# Access Compliance Report

## Public Rights-of-Way

### (Curb Ramps)

Intersection ID: 43670	Main Street: S_TRYON_ST	Cross Street: CORSICA_FOREST_DR	Location: NW
ADA ID: 3920D8F8A1AC	Ramp Type: Perp	Initial Pass/Fail: Fail	Overall Compliance: No
Severity Score: 26.25			
Codes/Mitigation Info/Possible Solution		Field Measurements/Component Compliance

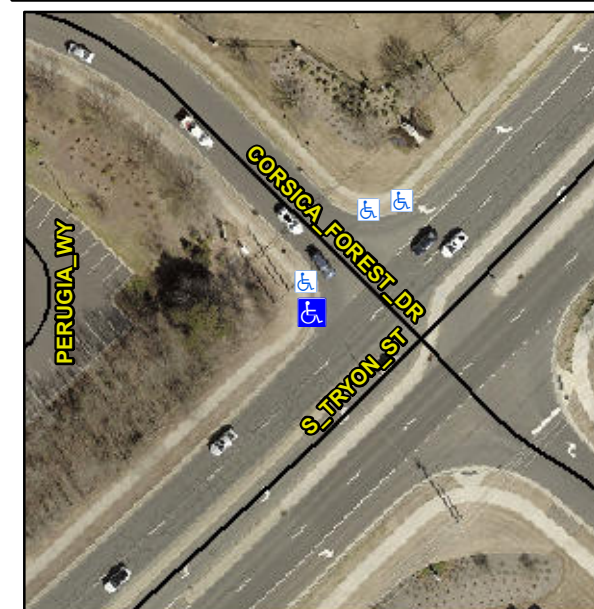
**R304.2.2, R304.5.3**

Compliance	Description	Data	Compliance	Description	Data
N/A	Ramp Length (in)	48.0	No	Ramp Slope (%)	12.9
Yes	Ramp Width (in)	48.0	No	Ramp XSlope (%)	2.6
N/A	Flare Type LT	N/A	N/A	Flare Type RT	N/A
N/A	Flare Slope LT (%)	N/A	N/A	Flare Slope RT (%)	N/A
N/A	Flare Traversable LT?	N/A	N/A	Flare Traversable RT?	N/A
N/A	Landing Length (in)	N/A	N/A	DWS Provided?	N/A
N/A	Landing Width (in)	N/A	N/A	DWS Contrast?	N/A
N/A	Landing Slope (%)	N/A	N/A	DWS Length (in)	N/A
N/A	Landing X Slope (%)	N/A	N/A	DWS Full Width?	N/A
N/A	Landing Curb? (Y/N)	N/A	N/A	DWS Offset (in)	N/A
N/A	Shared Landing?	N/A			
N/A	Gutter Ponding?	N/A	N/A	Gutter Slope (%)	N/A
N/A	Gutter Lip Ht (in)	N/A	N/A	Gutter X Slope (%)	N/A
N/A	Painted X Walk1?	No	N/A	Painted X Walk2?	N/A
	X Walk 1 Direction	To SE		X Walk 2 Direction	N/A
N/A	X Walk 1 Width (in)	N/A	N/A	X Walk 2 Width (in)	N/A
	X Walk 1 Slope (%)	0.4		X Walk 2 Slope (%)	N/A
	X Walk 1 X Slope (%)	2.3		X Walk 2 X Slope (%)	N/A

**Remove & Replace Entire Ramp.**
